REMARKS

Application Number 09/714,325
Amendment dated February 24, 2004
Reply to Office Action of November 5, 2003

Fig. 1

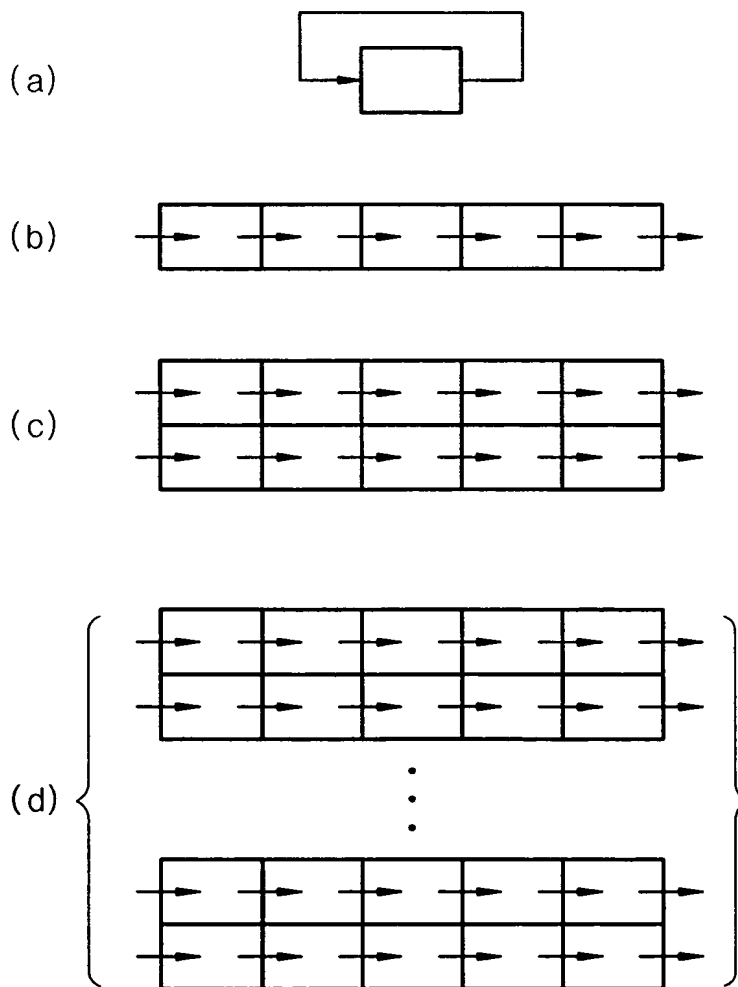
Figures 1, 2A, 2B, and 3 are objected to as not containing the legend "Prior Art." The drawings are amended herein to add the legend to the drawings. It is believed that the objection to the drawings is overcome. In item 4 of the Office Action, the drawings are also objected to with regard to proper labeling in accordance with MPEP section 608.02 (g). The section of the MPEP refers to the labeling of Prior Art drawings. It is believed that the amendments to the drawings, adding the legend "Prior Art" to the drawings, overcomes this objection as well.

The Brief Description of the Drawings section has been amended such that Figures 1, 2A, 2B, and 3 are referred to as "Prior Art."

Fig. 7

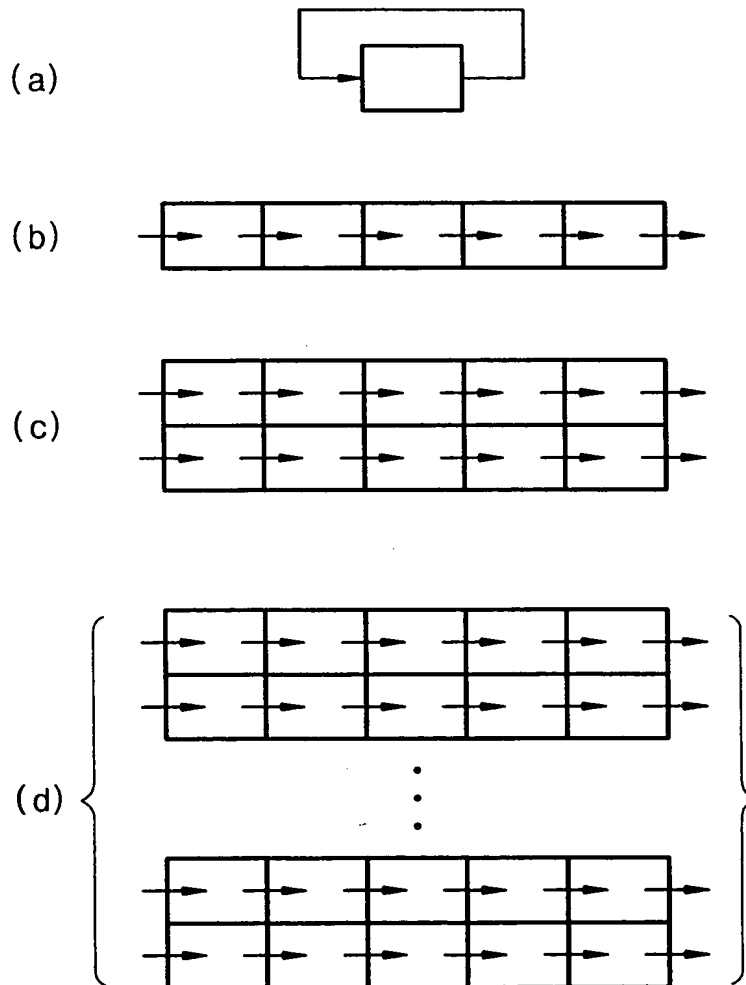
The drawings are also objected to as not showing every feature of the invention specified in the claims. In response, new Figures 7, 8, and 9 are submitted herewith for substitution into the application. The new figures illustrate execution of a routine composed of unrepeatable instructions. Corresponding description of the drawings is also added to the specification at page 5, line 14 and at page 7, line 13. The new figures and new description are added to clarify the application. The element of the invention of storing unrepeatable instructions would be understood by one of skill in the art. For example, referring to new Figure 7, Routine 1, including operations A and B, Routine 2, which includes operations C, D, and E, and Routine 3, including operations F and G, are executed serially. The serial storage of the routine addresses is shown in Figure 8, and the claimed trace cache storing addresses corresponding to each instruction is illustrated in Figure 9. The material illustrated in these figures would be readily understood to one of skill in the art from the original disclosure. For example, at least claim 1 clearly discloses the illustrated features of the invention by stating, "... if a routine composed of unrepeatable instructions is to be executed, storing an address corresponding to each instruction in the trace cache according to an order of executed instructions. ...". No new matter is added by the new drawings or the added description in the specification. Furthermore, it is believed that the objection to the drawings is overcome.
